Statement of Environmental Effects & Bushfire Risk Assessment

Section 4.55 (2) Modification Application: -

Amendment to NSW Rural Fire Service requirements
at no.'s 100A and 102 Wakehurst Parkway,
Elanora Heights

Approved under Notice of Determination No. DA2023/1123
(PAN-360459),
dated 27 February 2024

Extract of the Right of Carriage (ROW) with a variable width of 3.5 metres and 5 metres (shown in green tone)

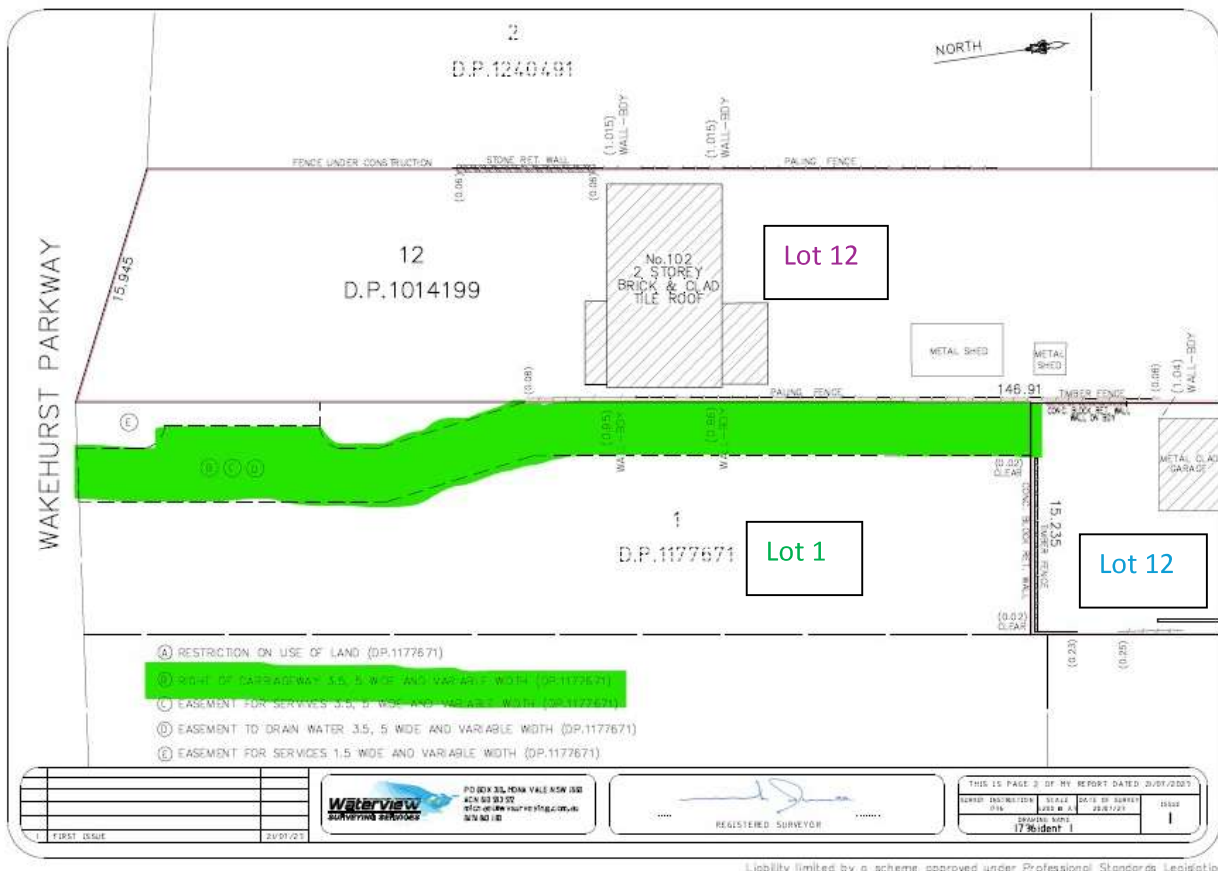
The property access for Lot 2 is afforded by an existing driveway and is an existing Right of Carriage (ROW) with a variable width of 3.5 metres and 5 metres (shown in green tone below).

We point out that we did not seek to widen this existing driveway/ROC as part of the approval process for a simple boundary adjustment.

To comply with the 4 metre property access condition, it would mean that existing dwellings and improvements at no. 100 Wakehurst Parkway (Lot 1) and 102 Wakehurst Parkway (Lot 12) would require invasive and costly demolition works.

This Modification Application seeks to demonstrate that firefighter pedestrian access for Lot 2, instead of fire truck (vehicular) access, is suitable as a performance-based solution under section 5.3.2 of PBP.

- Should an additional water supply be required, fire hydrants are available at multiple points along the Wakehurst Parkway, and
- A turning area is not required as fire truck access into Lot 2 and will not be relied upon.

Therefore, the land owners request Condition 4 is deleted as it has been demonstrated that fire truck (vehicular) access into Lot 2 is not required based on the low bushfire risk and there is no increase in density.
